EVELOPMENT NO.:	23035987
APPLICANT:	Dan Ferrone
ADDRESS:	8 PATAWALONGA FRTG GLENELG NORTH SA 5045
NATURE OF DEVELOPMENT:	Two-level detached dwelling with walls located on the southern side and western boundaries and a semi-undercroft car park
ZONING INFORMATION:	Zones: <ul style="list-style-type: none"> • General Neighbourhood Overlays: <ul style="list-style-type: none"> • Aircraft Noise Exposure • Airport Building Heights (Regulated) • Affordable Housing • Building Near Airfields • Prescribed Wells Area • Regulated and Significant Tree • Stormwater Management • Urban Tree Canopy
LODGEMENT DATE:	21 Dec 2023
RELEVANT AUTHORITY:	Assessment Panel at City of Holdfast Bay
PLANNING & DESIGN CODE VERSION:	P&D Code (in effect) - Version 2023.18 7/12/2023
CATEGORY OF DEVELOPMENT:	Code Assessed - Performance Assessed
NOTIFICATION:	Yes
RECOMMENDING OFFICER:	Alexander Stamatopoulos Development Planner
REFERRALS STATUTORY:	Nil

DETAILED DESCRIPTION OF PROPOSAL:

Above: Aerial showing the allocated spaces over the covered parking structure adjoining the subject site.

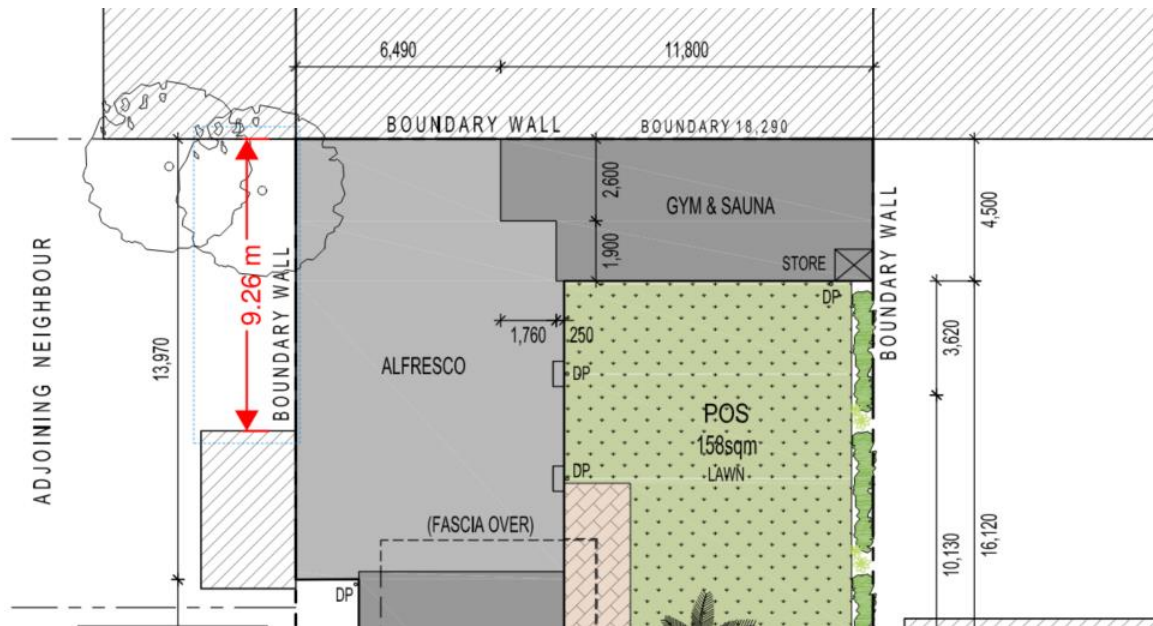
The wall associated with the alfresco and gym will abut an existing wall that is located on the boundary between the subject site and 13 North Esplanade. See below, which shows a photo of the wall itself and also an aerial showing the wall being associated with a covered communal parking area.

The wall associated with the alfresco and gym located on the western rear boundary will be screened by the existing wall therefore mitigating visual impacts. Overshadowing will not be unreasonable given the siting of the wall being on the western side boundary, being single storey and when considering it will be adjacent to a roofed area.
